SERVICE INFORMATION

Bulletin Nbr: 845-2282

Market: AT, AU, BE, CA, CH, CR, DE, ES, FI, FR, GB, GR, HK, HU, IE, IT, JP, NL, NO, PL, PT,
RU, SE, TR, TW, US, ZA**Rear spoiler vibrates and rattles****Cars affected**

Saab 9-3 Viggen from M99 to M01 VIN 17016680.

D845B007

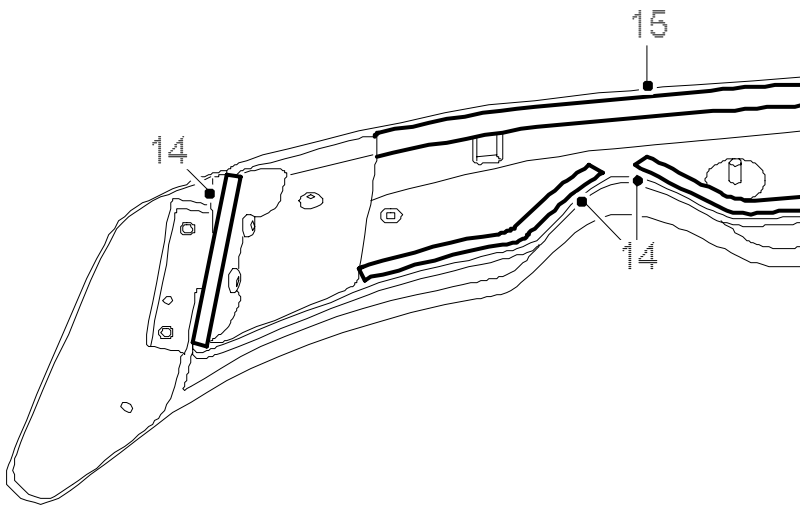
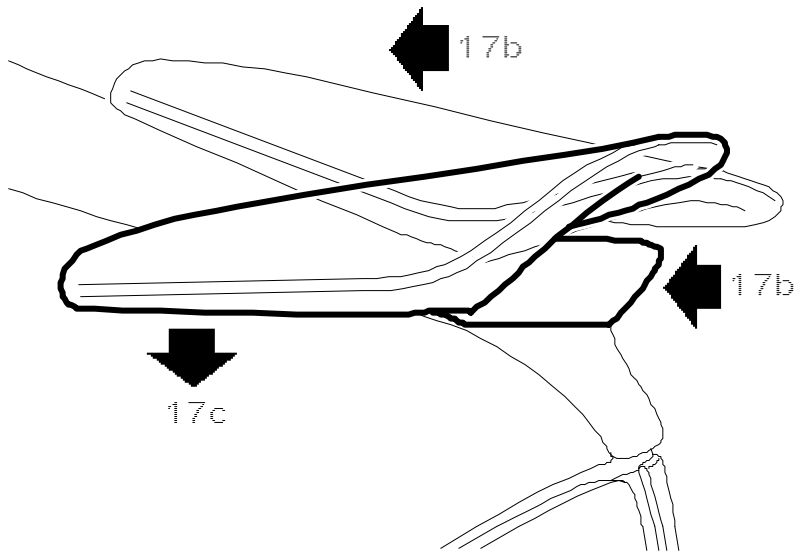
14. Fit double-sided tape to the spoiler. See illustration. Leave an opening for water to drain at the socket for the wiper arm.

Be careful when placing the tape down so it does not stick out.

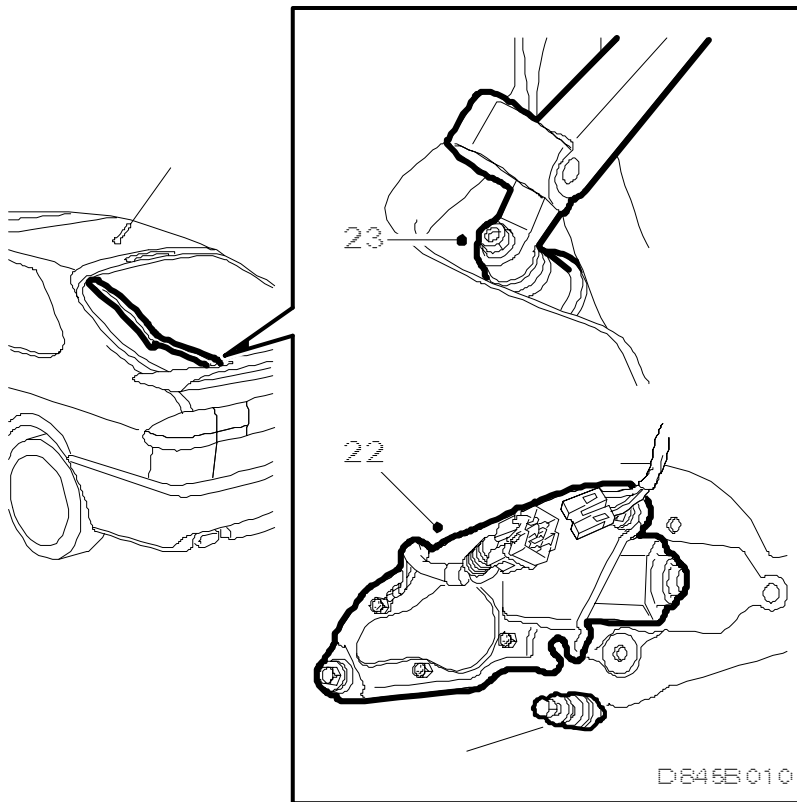
Do not mix up the right and left mounting. L = left and R = right.

The washers mean that the bolt heads protrude further and are thus closer to the painted surface of the rear wings. It is vital that the tailgate or bootlid is correctly adjusted to avoid the bolts damaging the paintwork.

21. Fit the spoiler's new outer mountings with nuts and washers.

Tightening torque: 5 Nm (3.7 lbf ft)
